IN THE DRAWINGS

FIG.5

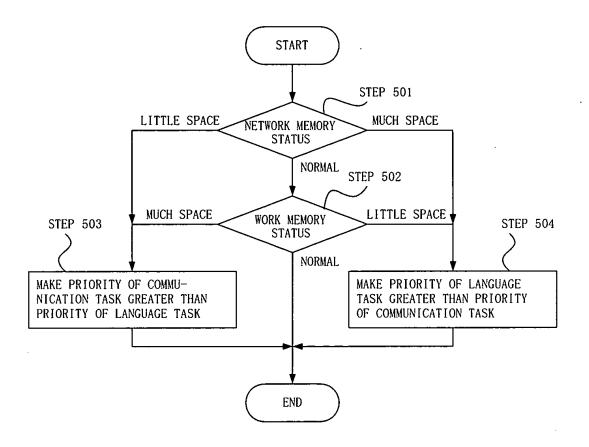
Please amend Figures 5 and 8 as shown in the enclosed replacement sheets. Figure 5 has been amended to show that (i) step 503 involves making the priority of the communication task greater than the priority of the language task and (ii) step 504 involves making the priority of the language task greater than the priority of the communication task. Figure 8 has been amended to show that (i) step 808 involves making the occupancy time of the communication task greater than the occupancy time of the language task and (ii) step 809 involves making the occupancy time of the language task greater than the occupancy time of the language task greater than the occupancy time of the language task greater than the occupancy time of the communication task.
